UNITED STATES PATENT AND TRADEMARK OFFICE

APPLICATION NO.	FILING DATE	FIRST NAMED INVENTOR	ATTORNEY DOCKET NO.	CONFIRMATION NO.
10/708,800	03/26/2004	Joy P. Prabhakaran	H0005591	2799
128	7590	06/20/2005	EXAMINER	
HONEYWELL INTERNATIONAL INC. 101 COLUMBIA ROAD P O BOX 2245 MORRISTOWN, NJ 07962-2245			ASSOUAD, PATRICK J	
			ART UNIT	PAPER NUMBER
			2857

Office Action Summary

FIG. 2

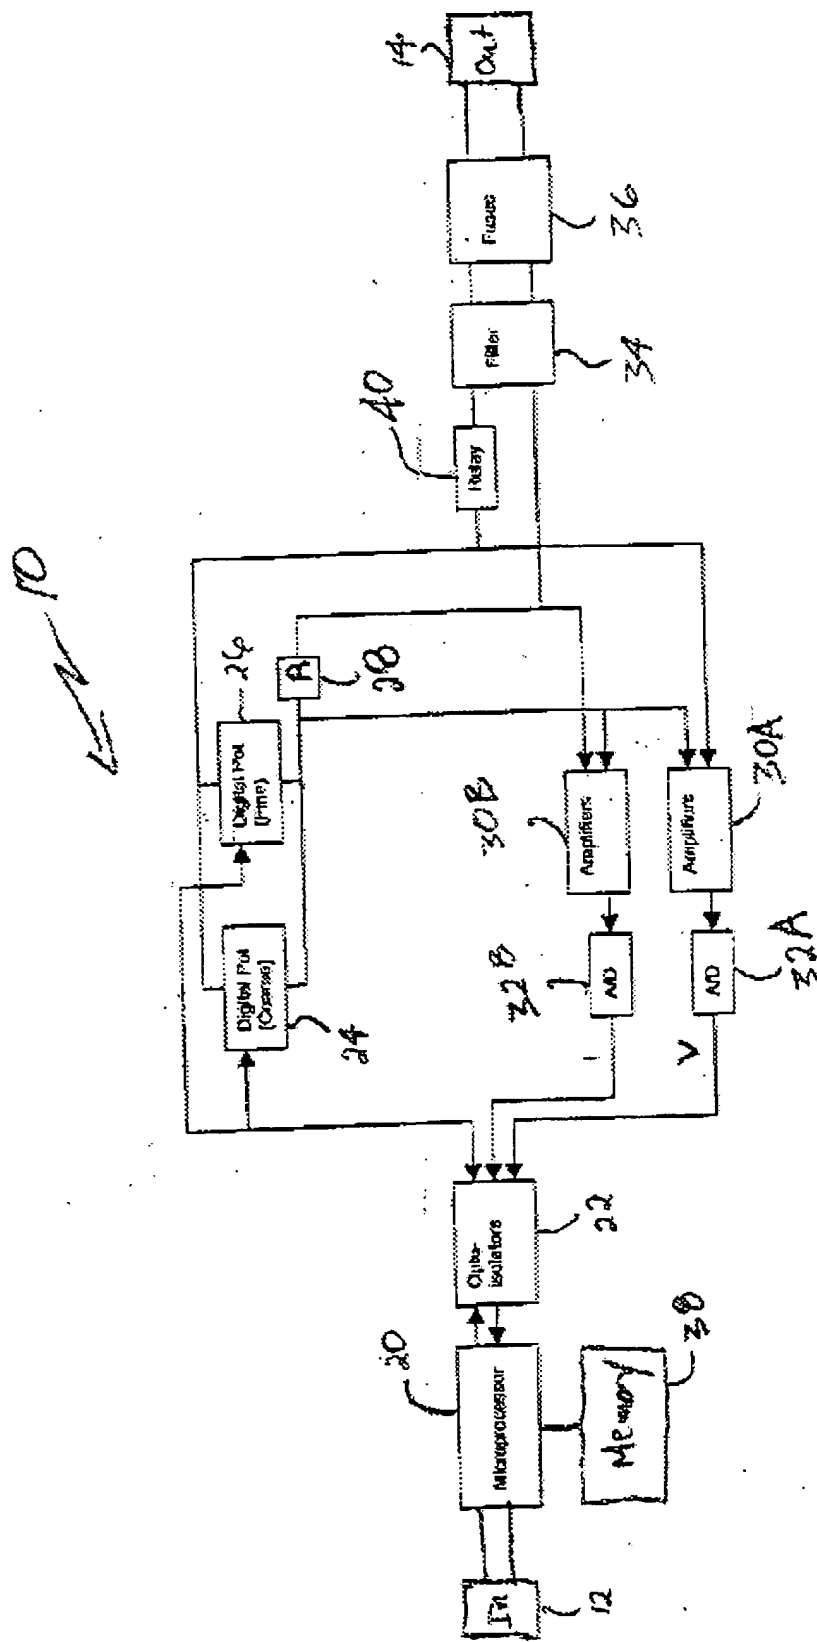
9. Claims 1-6 and 8-12 are rejected under 35 U.S.C. 102(e) as being anticipated by Gruszecki et al. (US 2004/0252750 A1) filed 6/12/03 and published 12/16/04. Note that Fig. 2 of Gruszecki et al. is reproduced below.

10. As per independent claim 1 which is simply a "plurality of digital potentiometers connected in parallel," see at least Fig. 2 of Gruszecki et al. and also the following passages from Gruszecki et al.:

Referring now to FIG. 2, there is shown a more-detailed block diagram of one embodiment of the temperature repeating system 10. In addition to the input and output connectors 12, 14, the temperature repeating system 10 includes a microprocessor 20, optical isolators 22, a coarse digital potentiometer 24 in a parallel arrangement with a fine digital potentiometer 26, a current sense resistor 28, a pair of amplifiers 30A and 30B, a pair of analog-to-digital (A/D) converters 32A and 32B, a filter 34, fuses 36, and a non-volatile memory device 38 and a relay 40. The microprocessor 20 receives the temperature data from the input connector 12 and provides the appropriate control signals through the optical isolators 22 to the coarse and fine digital potentiometers 24 and 26 in order to set the resistance seen at the output connector 14 to the appropriate value. In this regard, since the coarse and fine digital potentiometers 24 and 26 are in parallel, the resistance seen at the output connector 14 is given by the following expression for parallel resistance...

12. As per dependent claims 3 and 9 which refers to a "control block" and in claim 9, a "processor," see at least para. 0005 of Gruszecki et al. which discusses the controller aspects which includes a microprocessor (see Fig. 2):

14. As per dependent claims 6 and 12 which refer to a series resistor, see at least current sense resistor 28 or the resistance provided by filter 34 or other series resistances provided for in Fig. 2 of Gruszecki et al.
